RE: Property Address 6289 Carnarvon St. Vancouver  
 Building Permit Application No. DB446600

**From:** Westerman, Denise  
**Sent:** Wednesday, August 10, 2016 10:05 AM  
**To:** Chen, Tony  
**Cc:** Schwebs, Saul; Lam, Matthew; Ryan, Pat (PDS); DOMINO (CITYVAN)  
**Subject:** 6289 Carnarvon St - spatial re-check please - letter # 2

I reviewed the updated plans yesterday and did a complete review of the plans and again below are my comments:

SITE PLAN

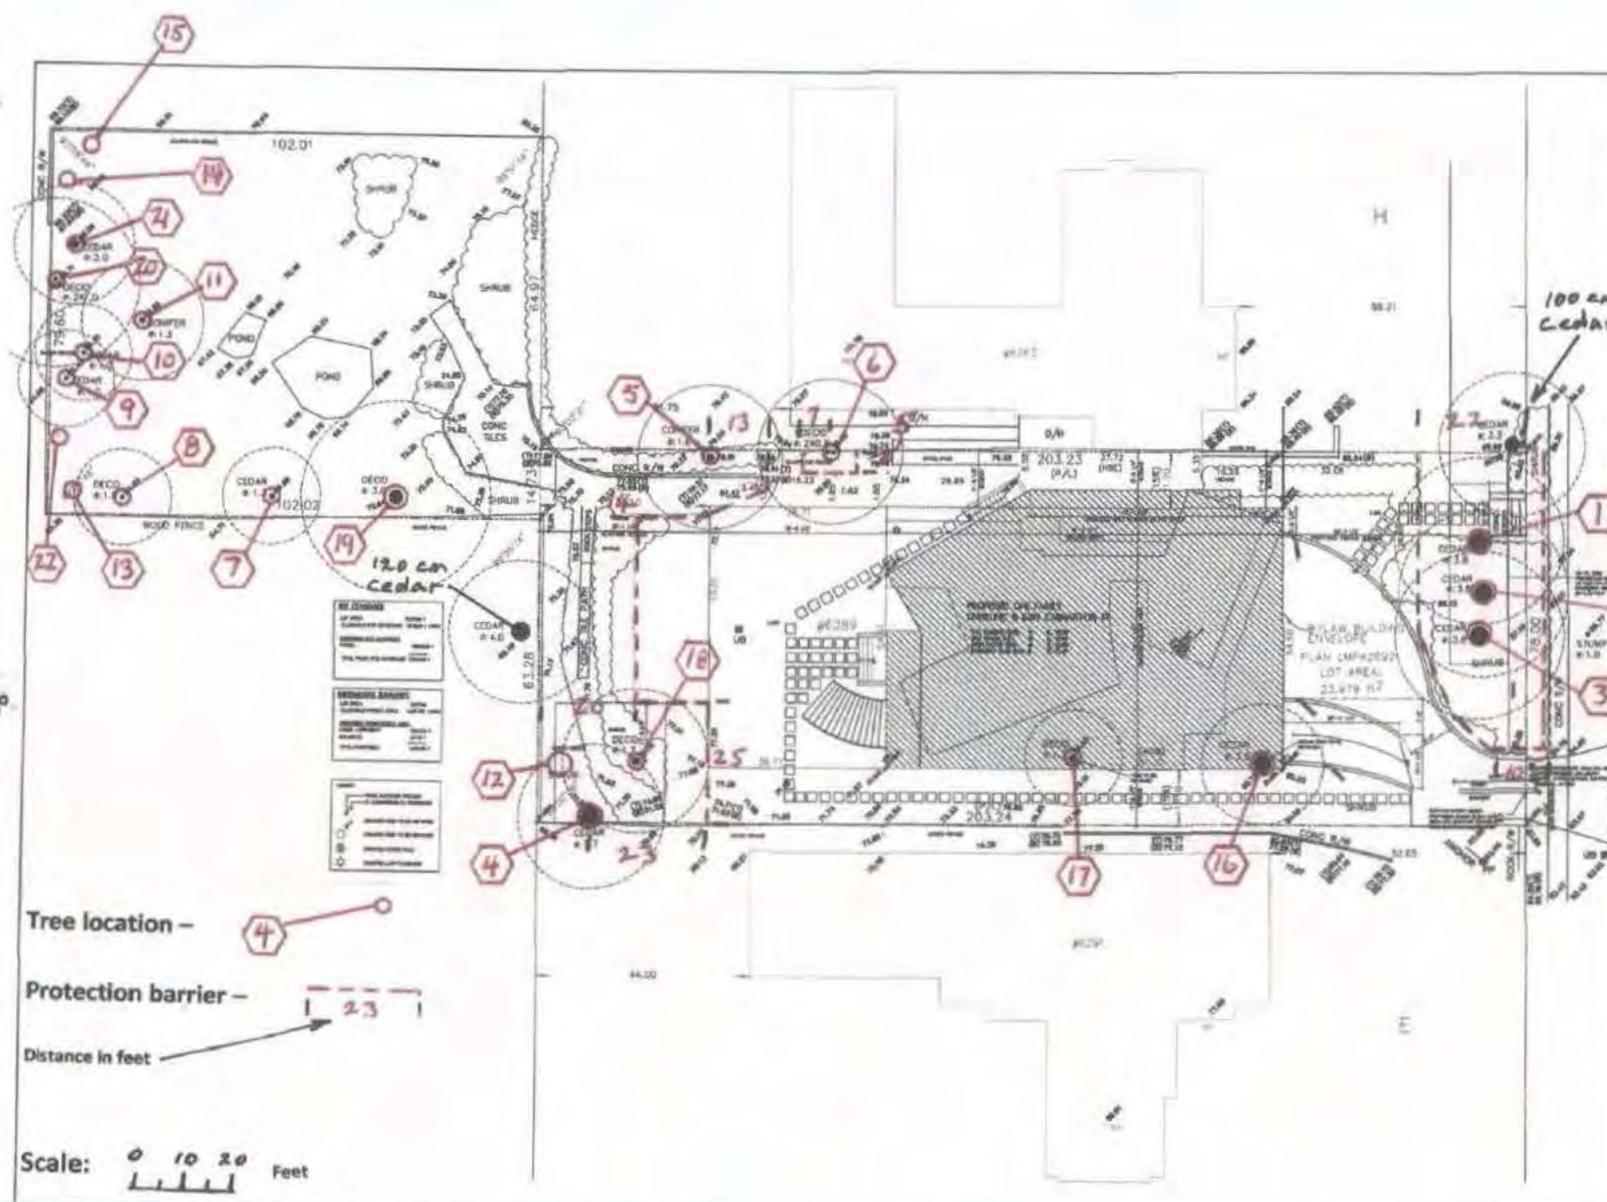
It really helps to show dimensions from tree trunks because arborists determine root protections setbacks using that convention.  
Except in a few cases, tree barriers dimensions measured from property lines are discouraged as a point of reference.

There is some concern about work in the front yard so we will ask for arborist supervision within 1 m of the tree barrier shown on the plans.

Copies of the letter of assurance and the revised site plan showing the dimensioned tree protection barriers accurately per the attached plan -- can be submitted to Katrina directly.

Please see the attached revised site plan with the tree protection as per the Arborist report.
